RAMER CREEK ESTATES SUBDIVISION

APPLICATION NUMBER 29 DATE October 18, 2007

REQUEST Subdivision

DETAIL SITE PLAN

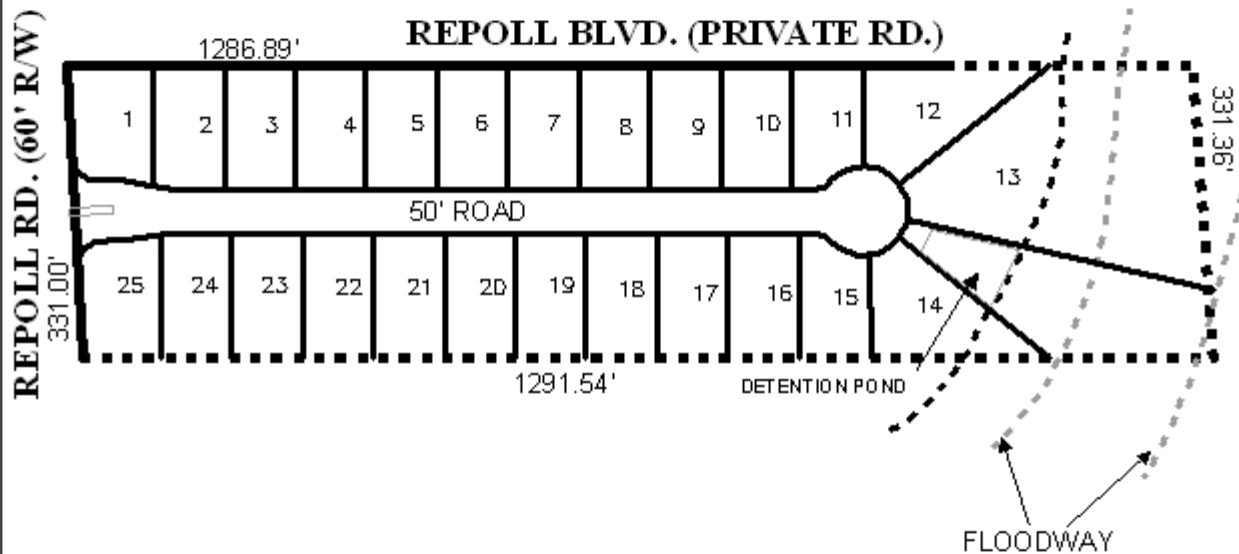
The application proposes a new street, which must be constructed and dedicated to Mobile County Engineering standards prior to signing the Final Plat. Lots 1 and 25 are corner lots; therefore, a note should be placed on the Final Plat limiting each lot to one curb cut each, with the size, design and location to be approved by County Engineering.

The new street, a cul-de-sac proposed for the subdivision, is approximately 940 feet long, which exceeds the 600-foot length recommended in Section V.B.6. of the Subdivision Regulations. To accommodate the proposed length, the plat should be revised to provide a street-stub to the parcel to the South near the midpoint of the proposed street, and to facilitate future connections as the general area is developed.

The requirement for a street-stub to the South is based upon Section V.B.1. of the Subdivision Regulations, which states: "The street layout shall also provide for the future projection into unsubdivided lands adjoining of a sufficient number of streets to provide convenient circulation." The parcel South of the site is approximately 16 acres is likely be the subject of future subdivision applications; hence the recommendation for street-stub should be required.

A retention/detention area is depicted and labeled on the preliminary plat; however, a common area located at the entrance of the proposed subdivision is not labeled. Therefore, the common area should be marked as such, and a note should be placed on the Final Plat stating maintenance of these areas will be the responsibility of the property owners.

No lot sizes in square feet were indicated on the plat; therefore the final plat should be revised to label each lot with its size in square feet, or a table depicting the same information should be provided.

While the site is in the County, the applicant's engineer will be required to certify that the stormwater detention, drainage facilities, and release rate comply with the City of Mobile stormwater and flood control ordinances, prior to the signing and recording of the final plat, if approved. The plat should also be revised to depict lot sizes to be illustrated in square feet either through labeling or the provision of a table on the Final Plat.

- 1) provision of street-stubs to the South;
- 2) placement of a note on the final plat stating that maintenance of the common areas, including retention areas, is the responsibility of the home owners;

- 3) labeling each lot with its size in square feet, or a table depicting the same information on the Final Plat;
- 4) placement of a note on the Final Plat stating that Lots 1 and 25 are limited to one curb-cut each with the size, design and location to be approved by County Engineering;

- 5) construction and dedication of the new street to County Engineering standards;
- 6) provision of a certification letter from a licensed engineer to the Planning Section of Urban Development, certifying that the stormwater detention, drainage facilities, and release rate comply with the City of Mobile stormwater and flood control ordinances, prior to the signing and recording of the final plat;

- 7) placement of a note on the plat stating that any lots which are developed commercially and adjoin residentially developed property must provide a buffer, in compliance with Section V.A.7. of the Subdivision Regulations; and

- 8) the submission of a letter stating the compliance of Section V.D.2. of the Subdivision Regulations prior to the signing of the Final Plat or documentation from the developer stating the location and design of a centralized sanitary system to handle the wastewater of the subdivision.
